## **MEMO – AUCKLAND TRANSPORT**

Subject: Technical Response – Auckland Transport (“AT”) Memo

## **NOTICE OF REQUIREMENT 6 REALIGNMENT ASSESSMENT**

**Subject:** Technical Response – Comparison of NOR 6 Original Alignment vs. Proposed Realignment through Delmore Development (Stages 1 & 2), Russell Road, Orewa

*Figure 1 - Indicative location of mid-span pier. Refer Long-section for bridge configuration.*

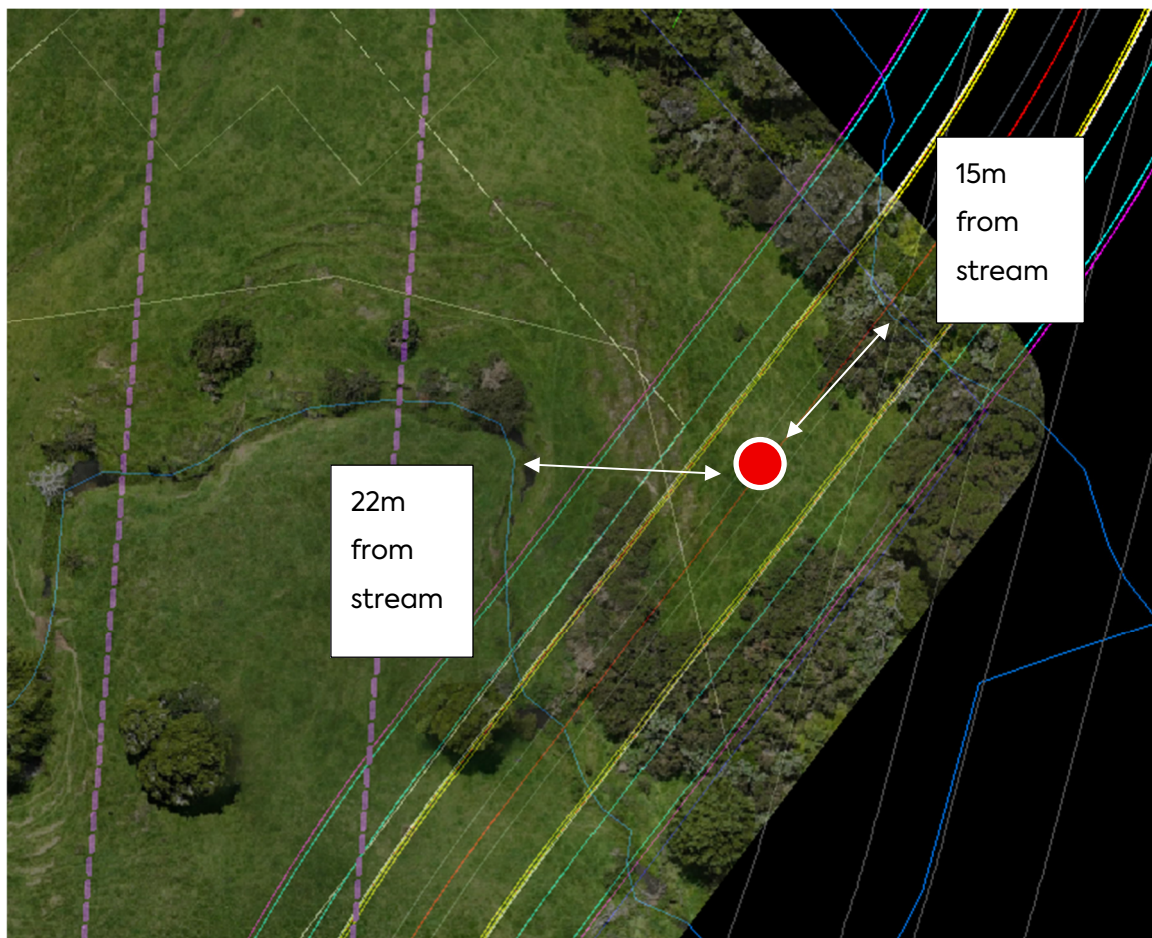
*b) Design refinement and optimisation of the bridge over a single stream (rather than two stream as proposed by the Applicant in the revised alignment) for the SGA NoR alignment has not been undertaken, so it’s not appropriate to use this as the basis for comparison.*

*c) The Applicants proposed alignment will require crossing two streams at a convergence point, which increases environmental risks and reduces opportunities to refine the design further.*

**Response –** The convergence point design has been expressly considered pre-lodgement by the applicant whilst modelling the alternative design. As a result of this investigation, the following is noted. The applicant's route does cross two converging streams, but its lower, shorter spans allow for a mid-span pier—unlike the AT alignment, whose greater height and geometry preclude such support. That pier can be sited well outside riparian margins, simplifying foundations and access. Overall, the two-stream crossing proposed by the applicant yields a lighter, more cost-effective structure with reduced embankment works, lower visual impact and shorter span lengths—offering clear advantages in constructability, maintenance and environmental mitigation, as outlined in the NOR 6 Memorandum (**Attachment A**). The proposed crossing significantly decreases the amount of covenanted bush requiring removal, so in that regard it is considered to be a superior alignment.

- The proposed alignment results in a 6,500 m<sup>3</sup> reduction in fill volume, due to more favourable alignment to the existing contours and a lower approach level.
- Lower abutment heights will be lower cost to construct the abutments.
- Shorter bridge span reduces structural load, foundation design requirements, and total construction cost. The option of a mid-span pier, could reduce bridge cost due to much shorter spans. The pier avoids stream alignments, being located minimum 15m from the centreline of each stream adjacent to the pier. No vegetation removal would be required for its installation. Refer to Figure 1 for indicative location of mid-span pier option.
- Intermittent pier option improves constructability and cost efficiency.
